## 21/1495 Exmouth Junction Ph4 Ph5

The Exeter Cycling Campaign is grateful for the opportunity to comment on the application for residential units at the Old Coal Yard Exmouth Junction Mount Pleasant Road.

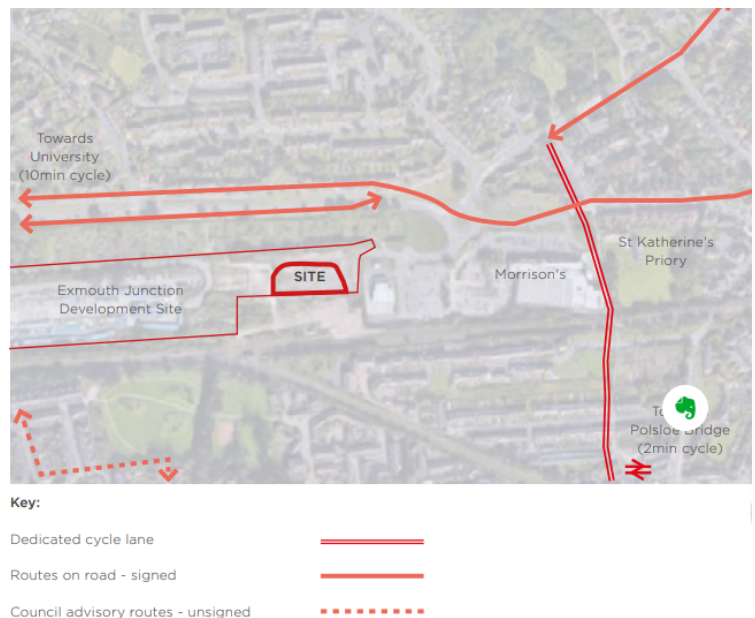
The current design of junctions and connectivity to the site currently falls short of this aspiration.

The diagram in section 3.2 of the Design & Access Statement demonstrates that there is insufficient connectivity from the east of the development site into the cycle network. From the east of the site one of the strongest desire lines of travel will be to St.Katherine's road. Currently residents of this development will need to navigate the mini-roundabouts and the Morrisons' HGV access road to reach St.Katherine's road. This route needs to give priority to people cycling and walking.

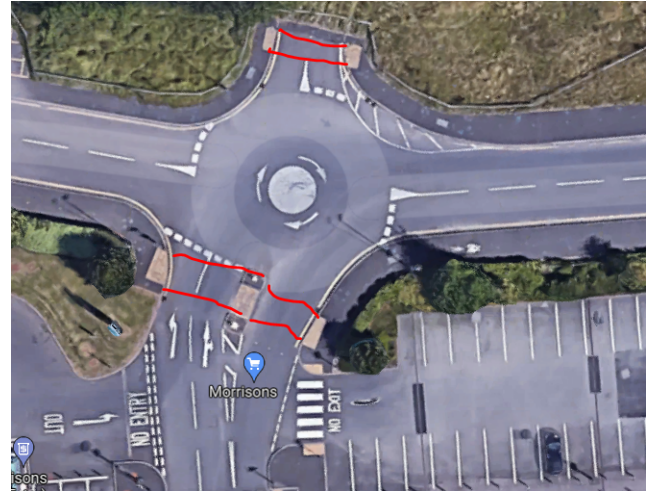
The upgrades that are necessary to provide this safe connectivity are:

- Give pedestrian and cycle priority across the arms of the small roundabouts
- Improve the outstanding conflict point where people cycling need to leave Prince Charles Road and access St.Katherines Road. This is part of the key E4 strategic Cycle route and is widely used by children going to/from school. This junction (highlighted) currently gives priority to the Morrisons HGVs as well as customers. This priority needs to be reversed so that children walking/cycling are prioritised over this junction, with Give Way signs for vehicles and permanent changes to the road surface to reinforce this priority.

**We ask that these upgrades are made a condition of granting the planning application.**
